Report to the Sydney Eastern City Planning Panel

Panel Reference	2018SCL052
DA Number	DA-498/2017
LGA	Waverley
Proposed Development	Demolition of existing structures; construction of a new 14 storey mixed use building comprising residential apartments, retail and commercial premises, and three basement levels; and associated planning agreement
Street Address	87-99 Oxford Street and 16-22 Spring Street, Bondi Junction
Applicant/Owner	Lindsay Bennelong Developments Pty Ltd
Date of DA lodgement	Originally submitted 23 November 2017 Amended plans submitted 19 June 2018 and 25 July 2018
Number of Submissions	Six submissions received
Recommendation	APPROVAL
Regional Development Criteria (Schedule 7 of the SEPP (State and Regional Development) 2011)	General development with a capital investment value (CIV) greater than \$30 million (the CIV of the development is \$64,535,556)
List of all relevant s4.15(1)(a) matters	<ul style="list-style-type: none"> • State Environmental Planning Policy 55 - Remediation of Land • State Environmental Planning Policy 65 - Design Quality of Residential Flat Development • State Environmental Planning Policy (Building Sustainability Index: BASIX) 2004 • Stat

Figure 1: The entrance to the through site link at Oxford Street. The yellow areas highlights the proposed dimensions. The purple area highlights the large and awkward area that does not adhere to CPTED principles.

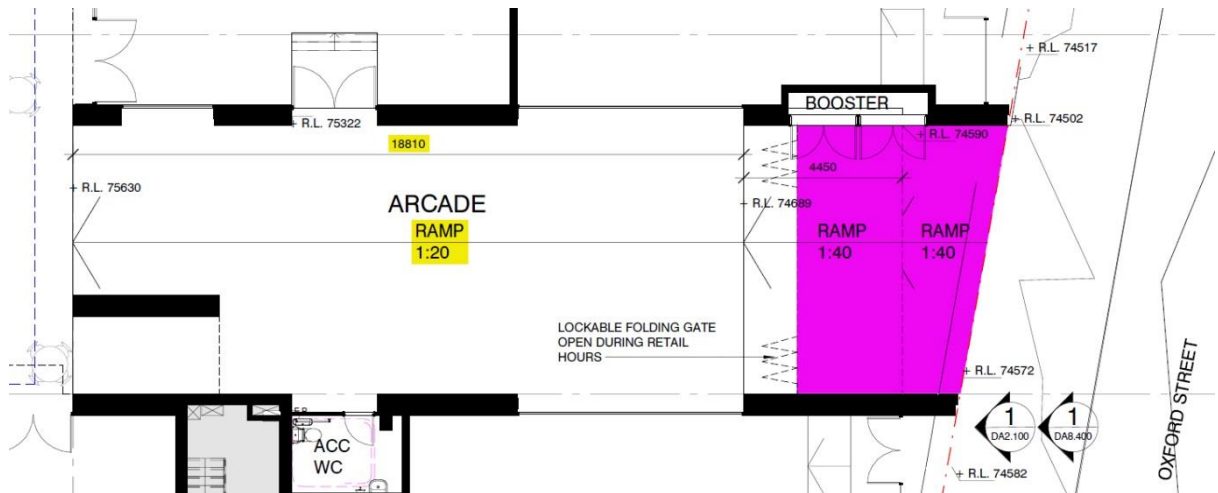
The current ramp design of the through-site link is inadequate. According to AS1428.1-2009, a 1:20 ramp will require a landing every 15m and hand rails to be considered a compliant ramp. The current ramp design is 18.81m long at a 1:20 grade with no handrails (refer to **Figure 1**) and is therefore non-compliant. It is recommended that the levels are adjusted to incorporate appropriate landings and provide a walkway with a gradient shallower than 1:20 from the entrance to avoid handrails and to avoid these non-compliant issues.

Further, the lockable folding gates should be further detailed in terms of the appearance and materiality of the gates. The gates should be moved closer to the Oxford Street boundary so to minimise opportunities for concealment during night-time.

Figure 12: Extract of Height of Buildings Map of Waverley LEP 2012 identifying the three separate height development standards that apply to the site (site is outlined in black)

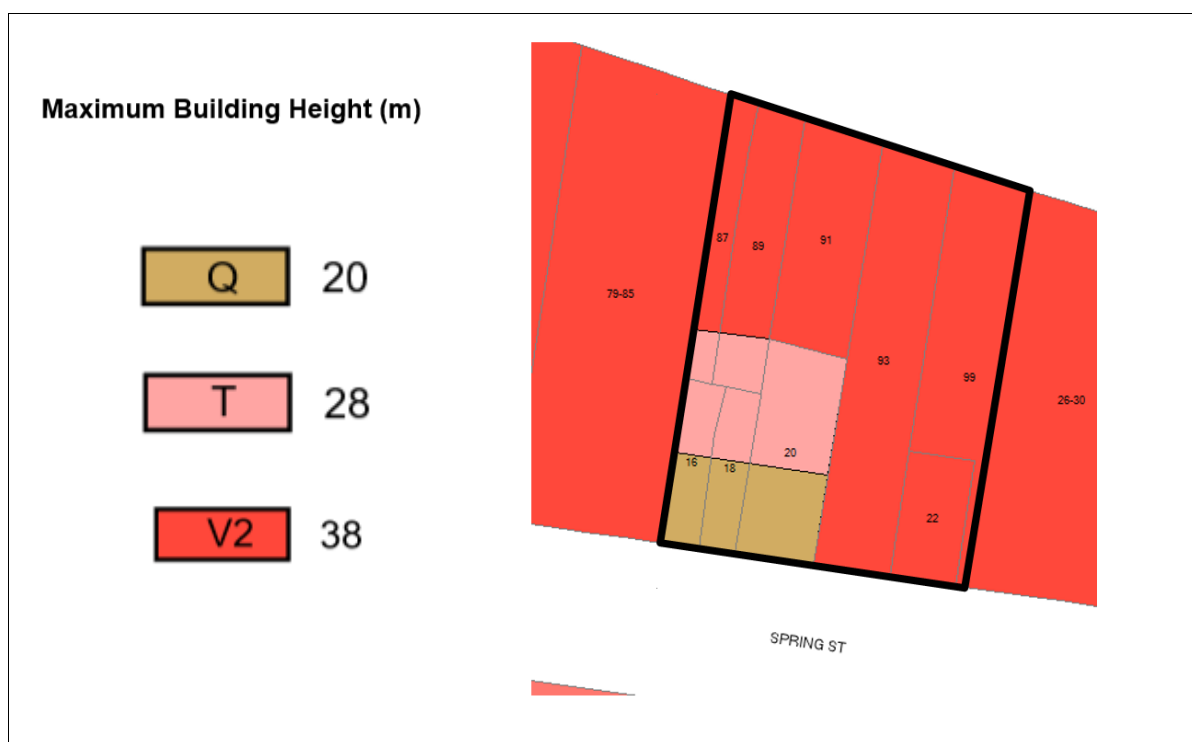
The site is subject to different height of buildings development standards under clause 4.3 of Waverley LEP 2012 as demonstrated in the height plane analysis in the 'Site analysis Sheet 2' submitted with the application. The majority of the site is subject to a height of buildings development standard of **38m** and part of the site that is currently known as 20 Spring Street is subject to height of buildings development standards of **28m** and **20m**, which anticipates the effect of clause 6.7(2)(d) of Waverley LEP 2012 in relation to protecting solar access to Norman Lee Place. **Figure 12** below is an extract from the Height of Buildings Map of Waverley LEP 2012 and identifies where the three height of buildings development standards apply to parts of the subject site.

The proposed development has an overall building height of 50.25m, which exceeds the overall height of buildings development standard of 38m prescribed under clause 4.3 of Waverley LEP 2012 by 12.25m or 32%. Measurements of the building height of key elements of the development are set out in **Table 6** below.

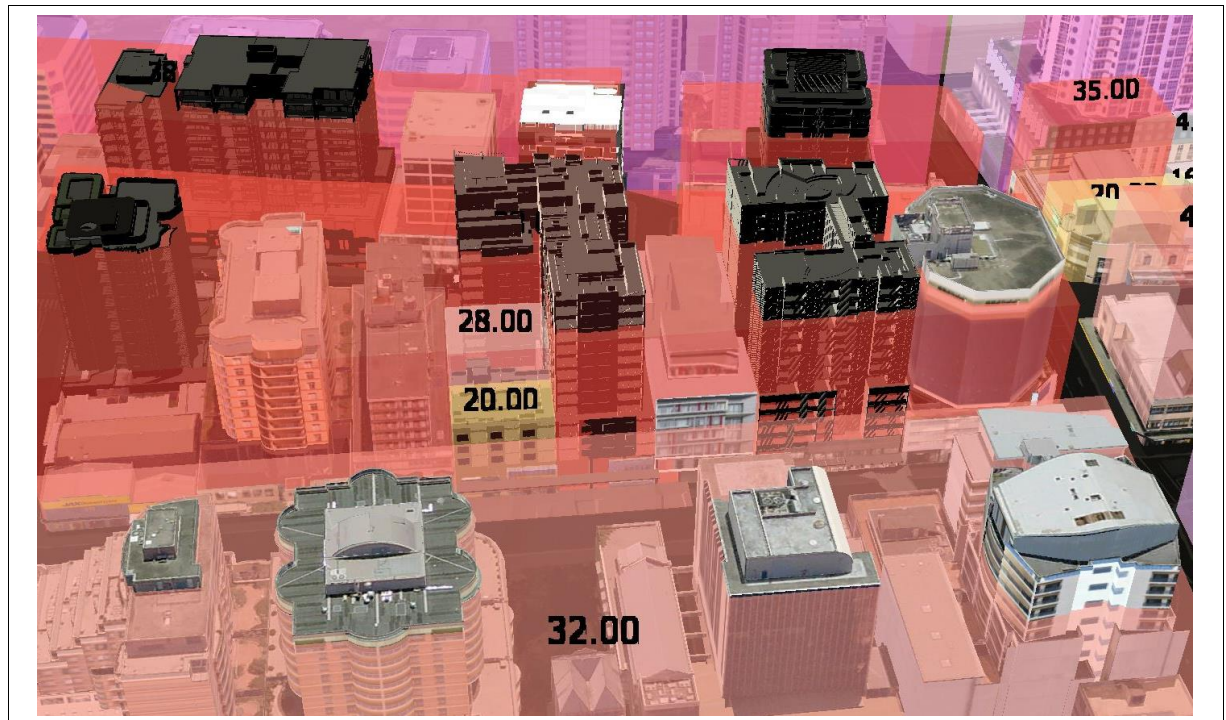
Figure 13 is a snapshot from the Waverley Digital Model to visualise the extent of the proposed development (shown in the centre of the snapshot) that exceeds the height of buildings development standard of 38m (NB. The plane of the height of buildings development standard of 38m is shown in red in the snapshot). The snapshot also shows the immediate context of the site in terms of the height of building development standards applying to adjacent sites (NB. The plane shown in pink represents a height of buildings development standard of 32m). The variation of the height of buildings development standard occurs within the uppermost floor levels of the northern, central and south-eastern portions of the proposed development.

Figure 13 demonstrates that the exceedance of the height of buildings development standard encountered by the majority of the examples outlined in **Table 7** equates to or manifests in these developments being two full storeys or additional floor levels above the development standard. In this regard, the overall number of storeys of these examples is 14.

Figure 14: Snapshot from the Waverley Digital Model showing the extent of shadowing impact caused by the proposed development on surrounding residential developments.

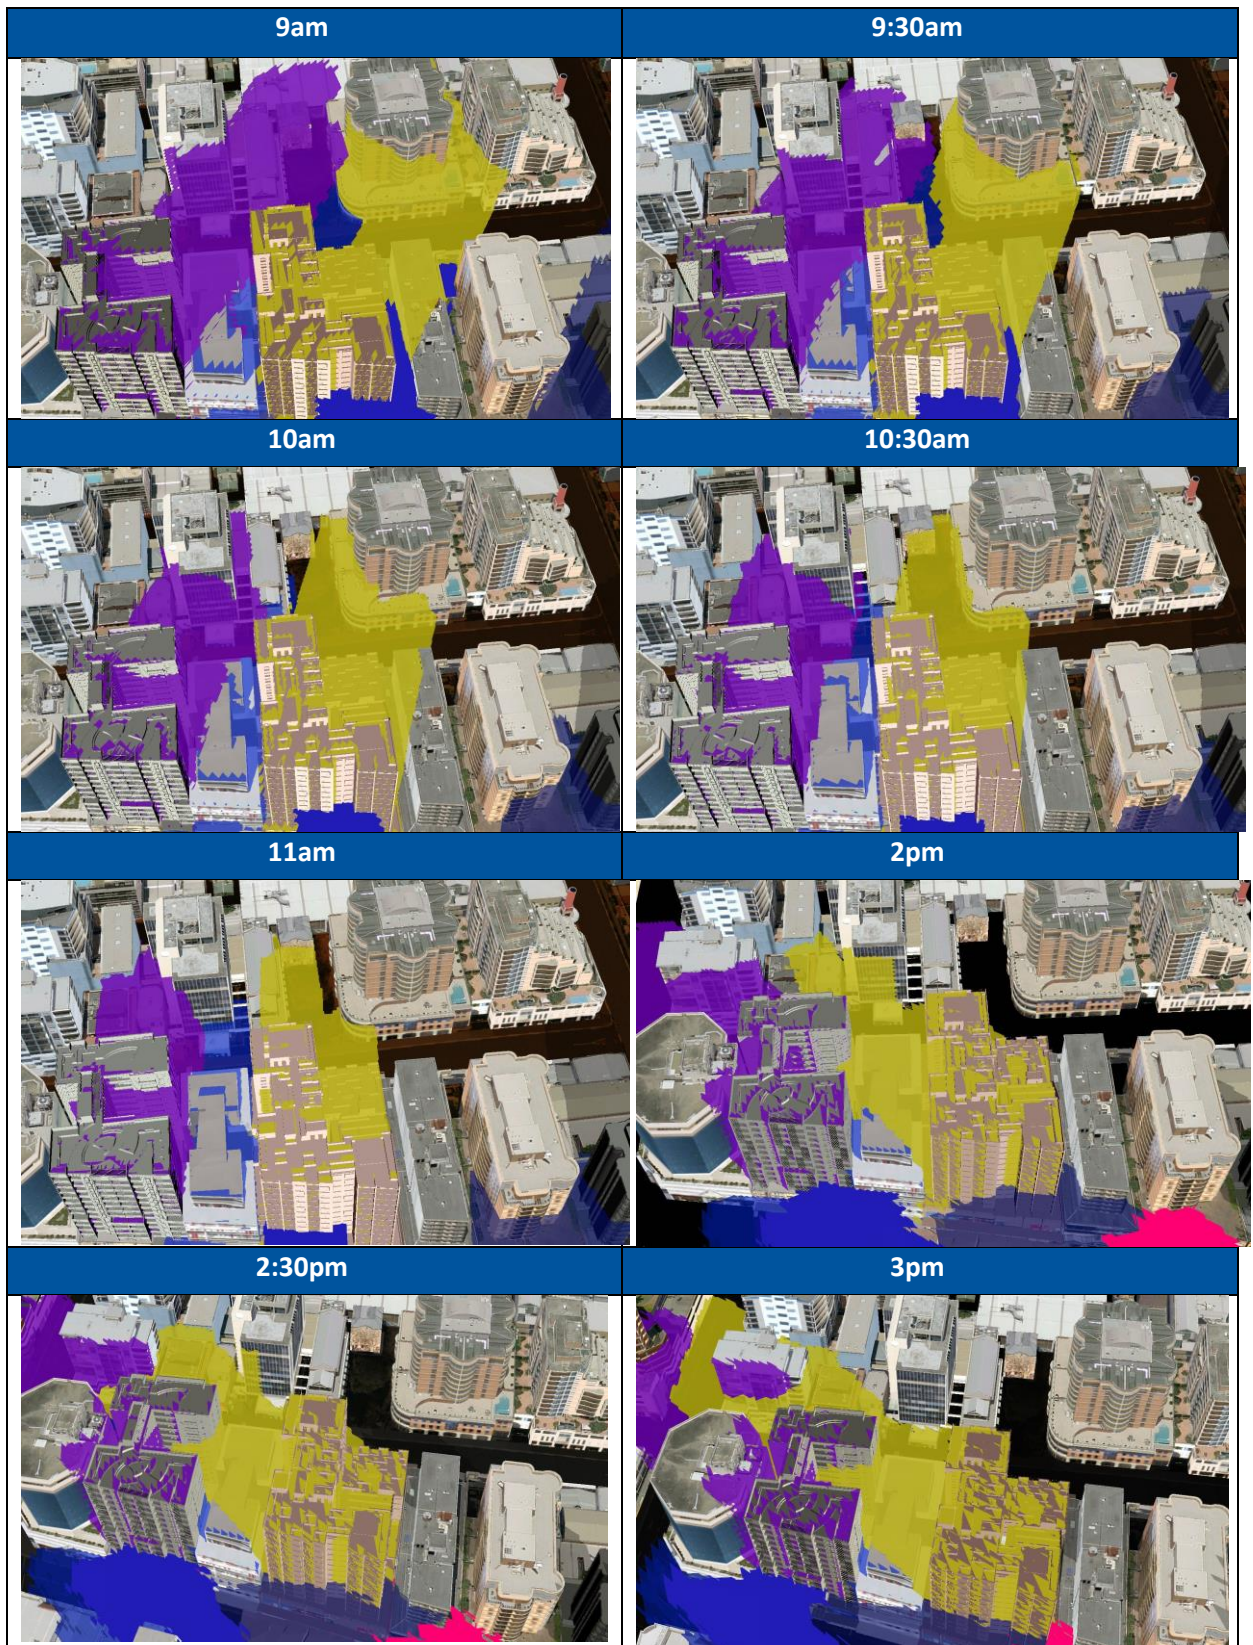
The shadowing impact analysis on the existing residential developments to the south of the site and on the southern side of Spring Street from the Waverley Digital Model is shown in snapshots from the Model, which are included in **Figure 14** below. The analysis is taken between 9am and 11am and 1:30pm and 3pm on 21 June as these periods are when the proposed development affects solar access received by the surrounding residential development.

The shadowing analysis shown in **Figure 14** reveals that the shadowing cast by the proposed development is relatively fast moving given the tower form of the development. The overall overshadowing impact upon these adjoining and adjacent residential properties is not expected to unreasonably reduce the amount and duration of solar access they receive during the winter solstice. The impact is therefore considered to be acceptable, particularly in a dense urban context such as Bondi Junction.

Figure 16: Views from eastern side balconies looking eastward on Level 12 of the building at 8 Spring Street (left snapshot showing existing view and right snapshot showing impacted view)

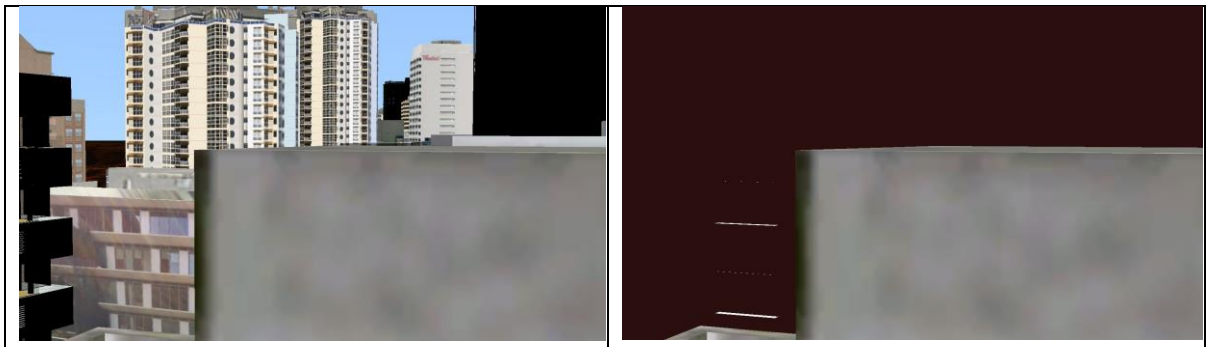
The submission was received from Unit 1201/8 Spring Street claims the proposed development will affect views enjoyed from this property. The property is two properties west of the subject site. The unit is on Level 12, which is just above the roof level of the adjoining building to the west of the subject site (known as 'The Waverley'). Views eastward across the subject site from Level 12 of the building at 8 Spring Street have been examined in the Waverley Digital Model. Snapshots of the views analysed from the Model are shown in **Figures 15, 16 and 17** below.

The analysis finds that the composition of views and outlook across the subject site are of tower development in the Bondi Junction Centre and glimpses of the districts of Bellevue Hill and Rose Bay beyond. There are no views of water and icons that are worthy of protection and retention in accordance with the view sharing planning principle from the NSW Land and Environment Court. Therefore, the proposed development will not result in adverse view loss impact. In any case, the exceedance of the height of buildings development standard is not expected to adversely affect views from surrounding residential properties that are situated higher than the proposed development in the Bondi Junction Centre.
